Peer Review of the Lido Key Federal Shore Protection Project

Sarasota County
Environmental Planning Department

October 2015

Figure 53 - Sediment Budget from 1987 – 2006.

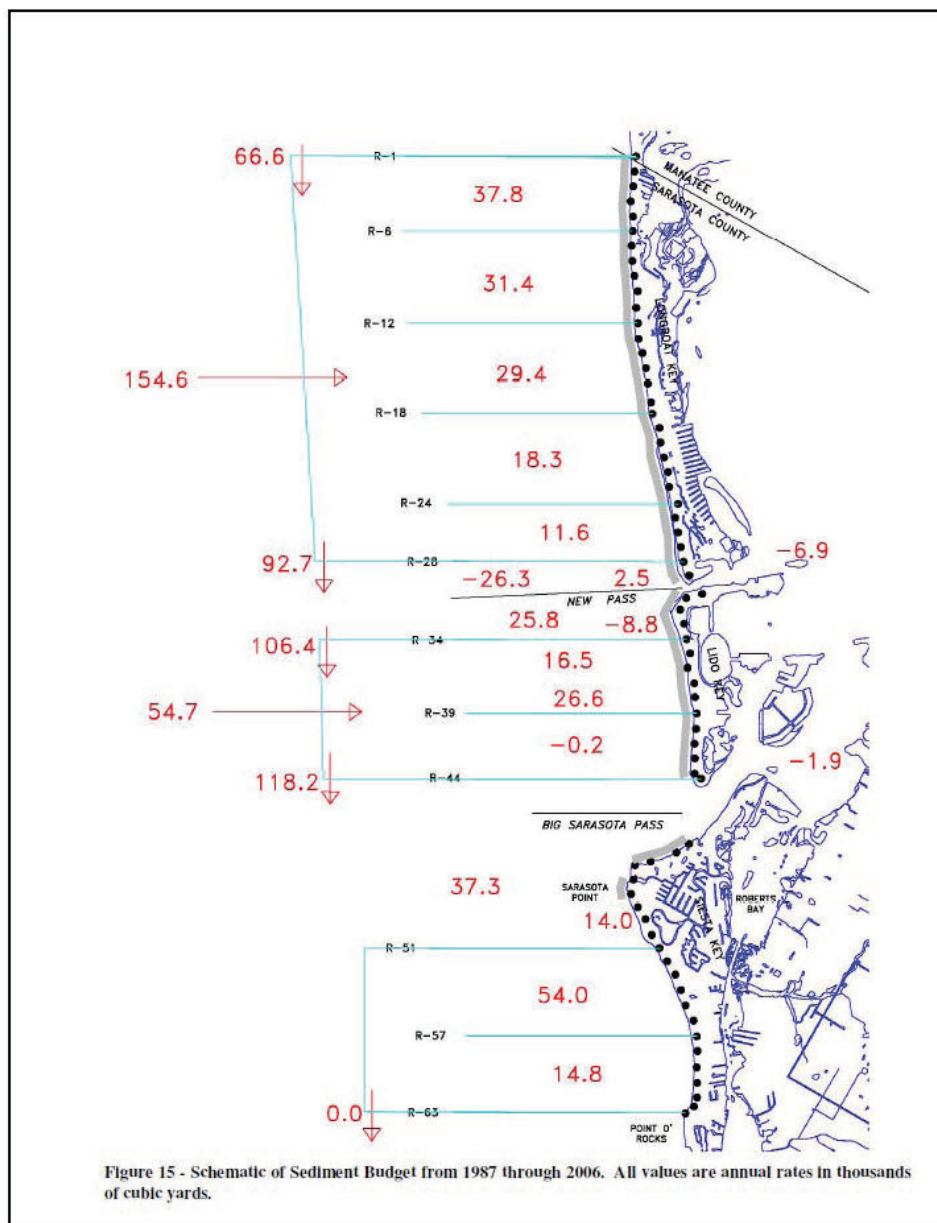
The sediment budget presented in the report and is repeated below (Figure 53: Sediment Budget from 1987 – 2006) is from previous studies. Data used to develop Figure 53 is not discussed in the reviewed reports. The budget demonstrates that there is a net gain to Lido Key beaches which we assume is due to nourishment events. A table showing beach nourishment volumes added to Lido Key during the period 1987 to 2006 should be provided to clarify sand volume added via anthropogenic means versus input through natural processes.

Figure 53 provides a sediment budget figure from a report that was not reviewed and was unavailable to the reviewers at the time of this review. The sediment budget presented within the figure appears to have errors as no material appears to be entering the Siesta Key area from the North and the sediment cells on Siesta Key do not balance in this area. Additional concerns are that the Lido Key cell of the sediment budget appears to suggest that Lido Key is not in need of much nourishment as the longshore gradient loss of sand to the island is only $118,2000 - 106,400 = 11,800$ cy/yr. This budget representation suggests that to maintain its present configuration Lido Key only needs 11,800 cy/yr, which further suggests that the placement of 1,300,000 cy is well over 100 years of nourishment for Lido Key? A table showing the volumes of material added to Lido Key during the period 1987 to 2006 should be provided to clarify what has been added via anthropogenic means and if sand is added to Lido Key from natural onshore transport. A representation of the sediment budget should also be prepared (if feasible) that shows the natural state of Lido Key erosion (i.e. without added nourishment) to clearly represent future concerns of Lido Key with and without the nourishment project.

Further work on the Figure 53 sediment budget is discussed in the report reviewed and summarized in Figures 54 through 57 by means of a method (Bodge,1993; USACE,2008) that provides an infinite number of solutions (due to more unknowns than equations) and then attempts a refined sediment budget using information derived from the previously formulated sediment budget. The approach utilizes a proprietary Matlab code to provide a “family of solutions” which, due to unverified (i.e. not peer reviewed) code, is subject to concerns. The final result of this “refined” attempt is provided in Figure 56 which provides what appears to be onshore transport (or anthropogenic placed material from offshore) in the Lido Key cell but no onshore transport in the Siesta Key cell. As the wave climate would be expected to be somewhat similar for the two cells, a rationale for the onshore transport differences noted needs to be provided if onshore transport is utilized in the sediment budget. No basis for the shoaling volumes provided from the north and south into the inlet is given, and Figure 56 appears to have errors as some of the cells do not balance. It is suggested that as a starting point for a “refined sediment budget”, the study should develop independent estimates of longshore sediment transport at the north and south boundaries of the sediment budget and then utilize a linear system of equations as per Weggel(1983) with a check for independence in equations as provided by Walton et al(2012). This approach in which an actual solution is given for sediment budget (rather than an “[infinite] family of solutions”) may provide added confidence in the recommendations within the report.

Figure 56 - Finalized Sediment Budget Existing Condition 1987 - 2006

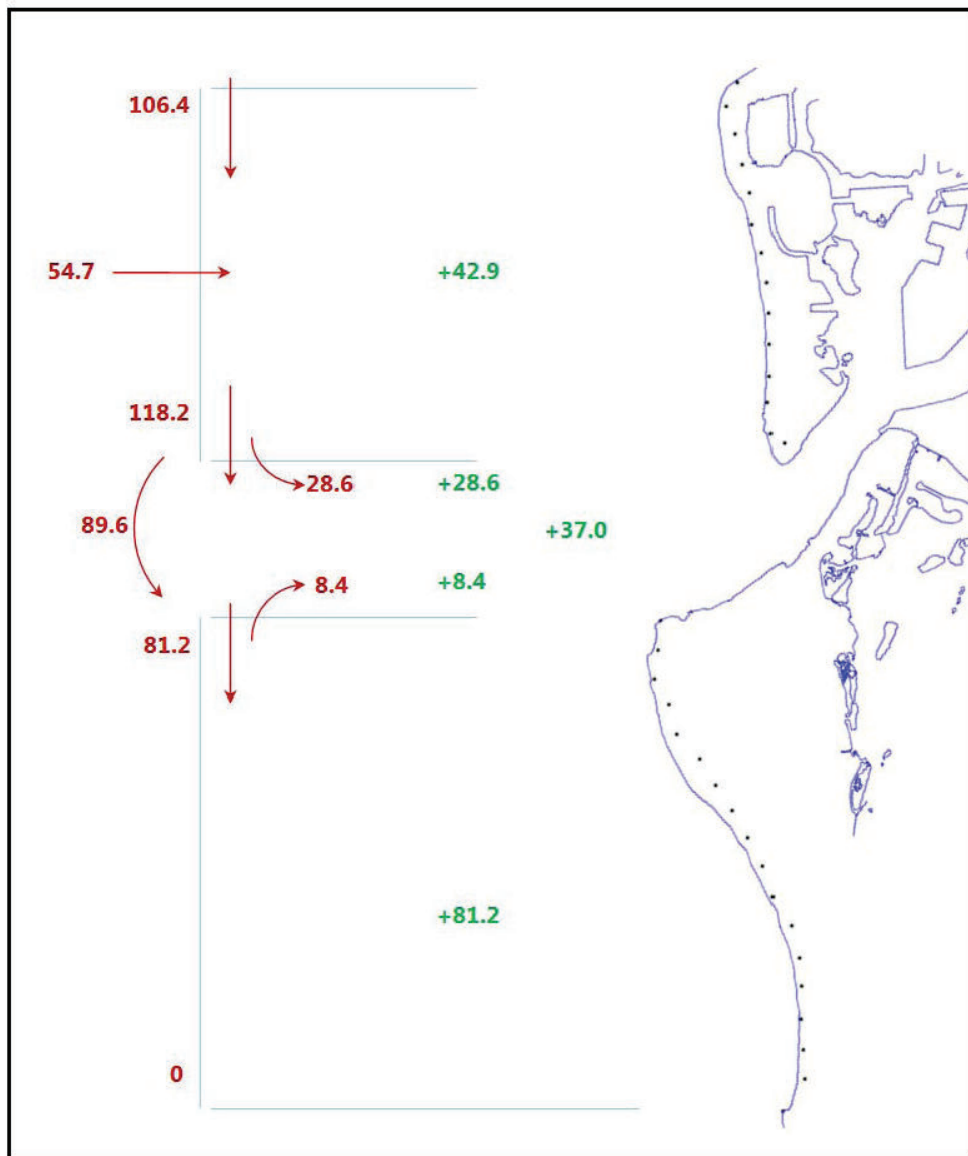
The USACE advanced the sediment budget estimates as summarized in Figure 56 repeated below. This budget was developed by the “family of solutions” method (Bodge, 1993; USACE, 2008) that provides an infinite number of solutions (due to more unknowns than equations). The sediment budget is then deduced using information derived from the previously formulated sediment budget. This approach cannot be reviewed as it uses proprietary (i.e. not peer reviewed) Matlab code to provide the “family of solutions”. The final result of the USACE refined budget demonstrates what appears to be either onshore transport or the addition of dredged material into the Lido Key cell. In both budgets, onshore transport in the Siesta Key cell is absent. As the wave climate would be expected to be somewhat similar for the two cells, rationale for the onshore transport differences (natural onshore transport or dredge material placement) should be provided. No basis for the shoaling volumes provided from the north and south into the inlet is given.

The report notes, “First, it was specified that net transport into the system is 106,000 cy/yr based upon the sediment budget developed from the Inlet Management Program (2008)”. In a major study such as this, the modeling and sediment budget work is highly dependent on net transport. This subject should be a high priority in the investigation however, there was no review of the net transport estimates provided by others. Also there was no discussion of the development of an independent estimate. Any net transport provided should be well documented including the rationale for accepting the chosen values. Additionally, sensitivity studies should be made to assess different results dependent on the uncertainty of the net transport. Numerous other cases where assumed sediment budget input values have been used without any rationale or independent investigation are noted in the report (i.e. “Further, it is **assumed** that bypassing from Lido Key is 53,000 cy/yr”; Finally, it was **assumed**, due to the significant amount of net transport from the north, that shoaling from Siesta Key is less than 20% of the total sediment volume entering the ebb shoal each year.”). The report states that “At the southern boundary of the study area at Point of Rocks, the net longshore sand transport was to the south at 0 cy/year”, which is undocumented and lacking discussion in the formulation of this conclusion.

Figures 176 and 177 – Big Sarasota Pass Ebb Shoal Volumes

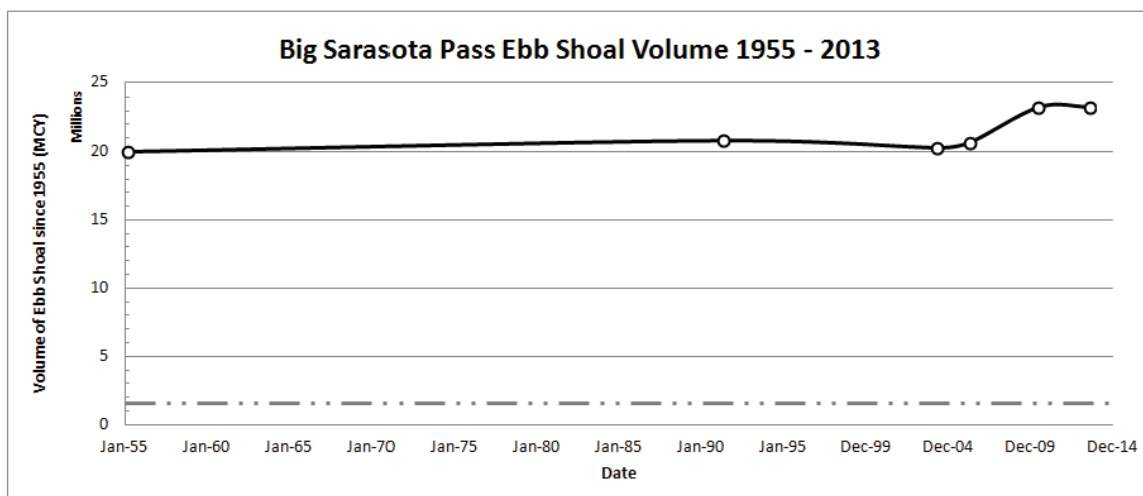
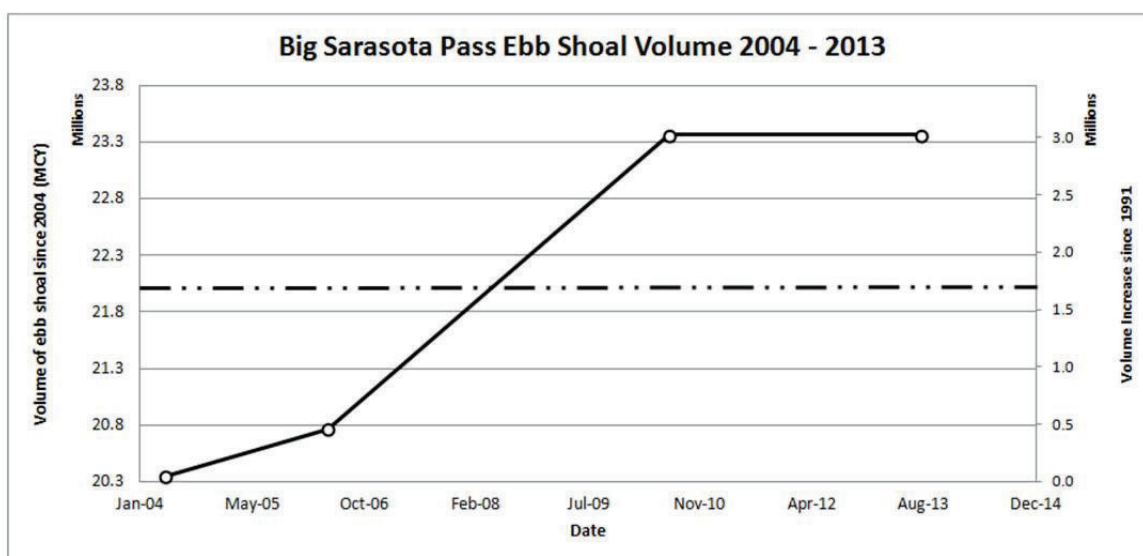
Figures 176 and 177 show the volume of the ebb shoal with time. Error bars on the survey data should be developed, shown, and discussed. To assess the quality and reliability of the results, the surveys should be shown along with the boundary (i.e. domain area) for the volumetric computation. Survey information documentation should also be provided. It is not clear that the same survey areas are involved in the volumetric computations nor that the data density and/or coverage is coincident or, if not corrected and documented. An independent assessment of the calculated ebb shoal volumes is not possible and, based on the lack of information, there is no commentary on the certainty of the calculations. Therefore, the statement that “*The volume of the ebb shoal has increased in the last decade ...*” may be appropriate however the quantity does not appear to be reliable. This potentiality needs to be thoroughly investigated as critical decisions concerning the ebb shoal dredging for back-passing are dependent on the accuracy of these calculations.

Figures 176 and 177 show volume of ebb shoal with time although no error bars are shown. To assess the quality and quantity of the data, the surveys should be shown along with the boundary (i.e. domain area) for the volumetric computation. Survey information documentation should also be provided in a table. It is not clear that the same survey areas are involved in the volumetric computations nor that the data density and/or coverage is the same. If this turns out to be the situation, it would be expected that the calculated ebb shoal volumes may entail considerable uncertainty and hence the statement that "The volume of the ebb shoal has increased in the last decade ..." may not be correct. This possibility needs to be thoroughly investigated as COE critical decisions concerning the ebb shoal dredging for back-passing are strongly dependent on it. Various CMS modeling done on the alternative dredging locations with regard to sediment pathways, transport vectors, integrated sediment transport vectors, and morphological change suffer the same concerns noted in previous commentary in the section entitled "*3.0 CMS modelling comments*".

Figure A-16 - Without Project Future Shoreline, Lido Key, Sarasota, FL

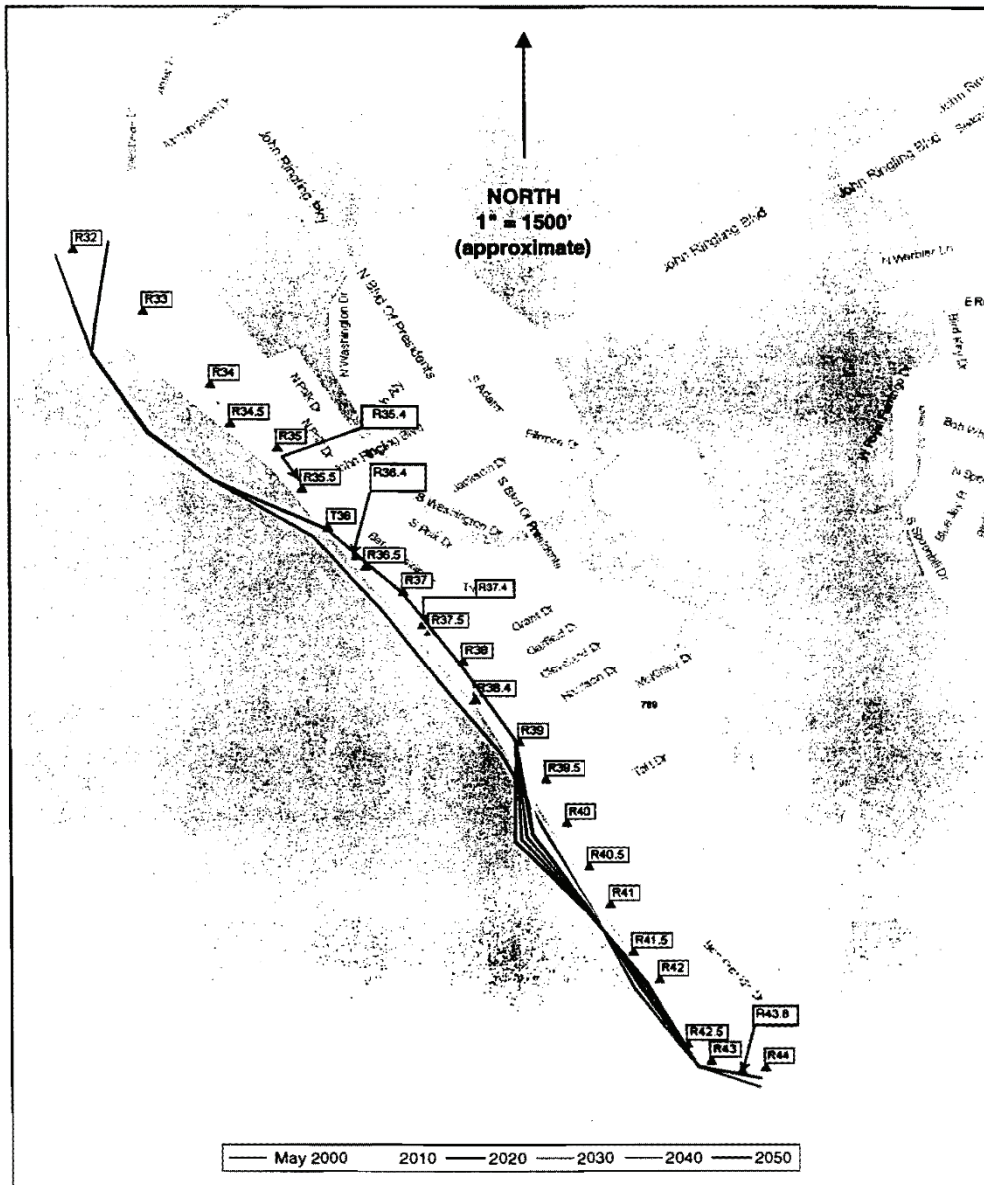
The potential impact of the no-action alternative is shown in Figure A-16: Without Project Future Shoreline, Lido Key, Sarasota, FL. These future shoreline projections are not clear as to which shoreline goes with which data. Most of the black and white figures of shoreline changes on Lido Key are illegible.

- Most of the black and white figures of shoreline changes on Lido Key are not readable;
- Figure A-16 future shoreline projections are not clear as to which shoreline goes with which data.

Figure A-21 - 1974 – 1992 Sediment Budget, Lido Key, Sarasota, FL.

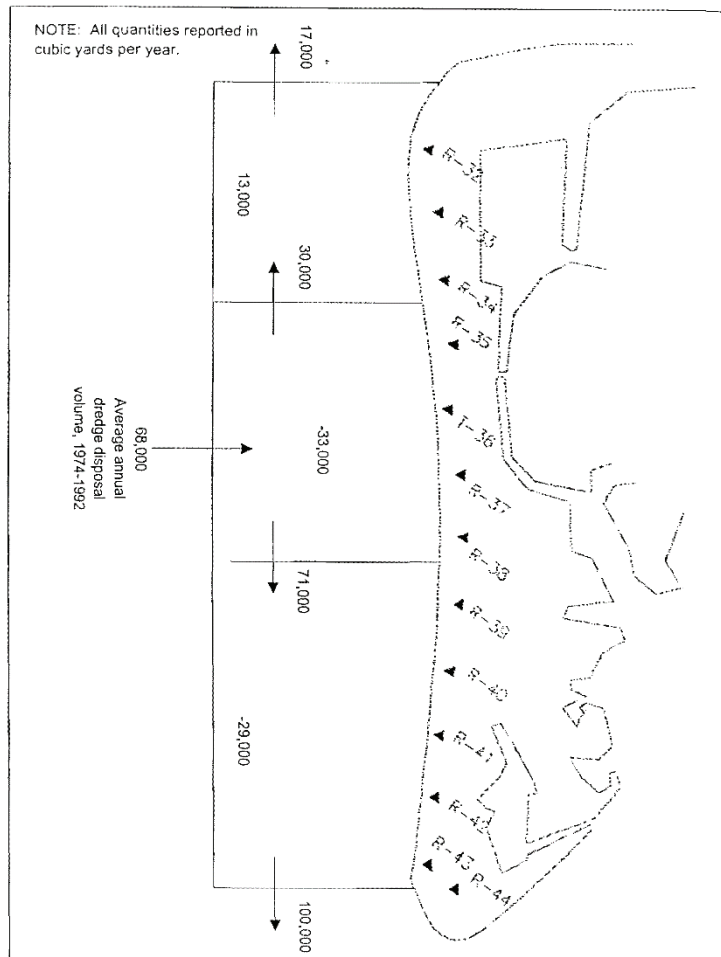
Also in the report, Wave Information Studies (WIS) wave hindcast data appear to have been used along with the REF/DIF 1.0 model to develop the longshore sediment transport calculations. Wave information from the WIS studies has changed over time with newer wave hindcast data replacing previously calculated hindcast data. Wave direction estimates based on WIS hindcast data are not confirmed (i.e. no blind verification of the developed data). The data used should be referenced and archived for comparison with present WIS

hindcast data to update the sediment budget developed below in Figure A-21: 1974 – 1992 Sediment Budget, Lido Key, Sarasota, FL.

- In the report, Wave Information Studies (WIS) wave hindcast data appear to have been utilized to develop some of the longshore sediment transport calculations along with the REF/DIF 1.0 model. Wave information from the WIS studies has changed over time from its inception with newer wave hindcast data replacing previously calculated hindcast data and the fact that wave direction estimates based on WIS hindcast data are of questionable reliability (i.e. no blind verification of the developed data), the data utilized should be referenced and archived for further checking and comparison with present WIS hindcast data for project design confidence of the sediment budget developed in Figure A-21.
